BOLLETTINO TECNICO

N° **139-414**

SUBJECT

BRACKETS NOSE INSTALLATION.

Figure 5

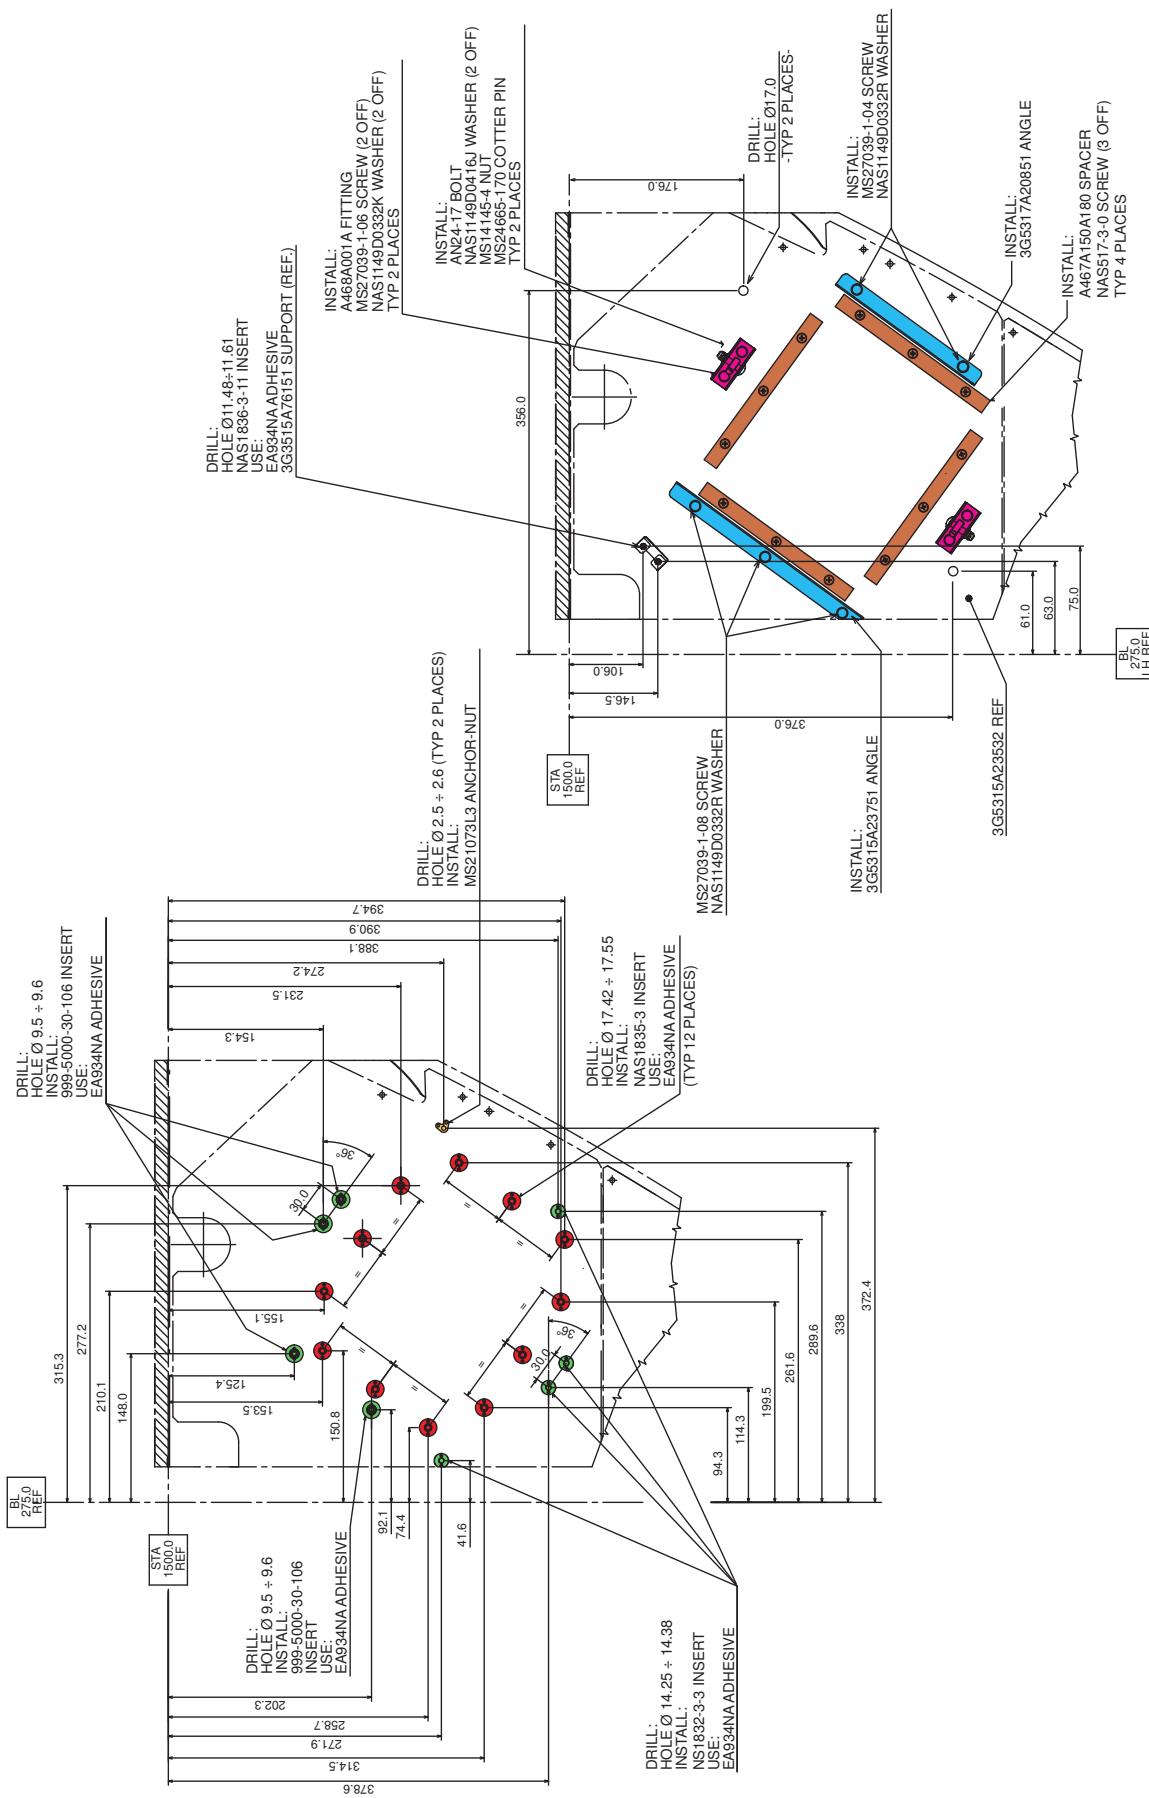
18.47 With reference to Figure 5, drill n° 4 holes $\varnothing 9.50 \div 9.60$, n°4 holes $\varnothing 14.25 \div 14.38$, n°12 holes $\varnothing 17.42 \div 17.55$, n°2 holes $\varnothing 11.48 \div 11.61$ and n°2 hole $\varnothing 2.5 \div 2.6$ on the LH rear panel P/N 3G5331A23133.

Indicated quotes are only for reference, coordinate with existing drainage installation.

18.48 With reference to Figure 5 Detail E, perform n°2 drain line holes $\varnothing 17$.

18.49 With reference to Figure 5 Detail E, install n° 4 inserts P/N 999-5000-30-106, n°4 inserts P/N NAS1832-3-3 and n°12 inserts P/N NAS1835-3 by means of EA934NA adhesive and n°1 anchor nut P/N MS21073L3.

18.50 With reference to Figure 5 detail E, install angle P/N 3G5317A20851 by means of n°2 screws P/N MS27039-1-04 and n°2 washers P/N NAS1149D0332K.

18.51 With reference to Figure 5 detail E, install angle P/N 3G5315A23751 by means of n°3 screws P/N MS27039-1-08 and n°3 washers P/N NAS1149D0332K.

18.52 With reference to Figure 5 Detail E install n°4 spacer P/N A467A150A180 by means of n°12 screws NAS517-3-0.

18.53 With reference to Figure 5 detail E, install n°2 fittings P/N A468A001A by means of n°4 screws P/N MS27039-1-06 and n°4 washers P/N NAS1149D0332K.
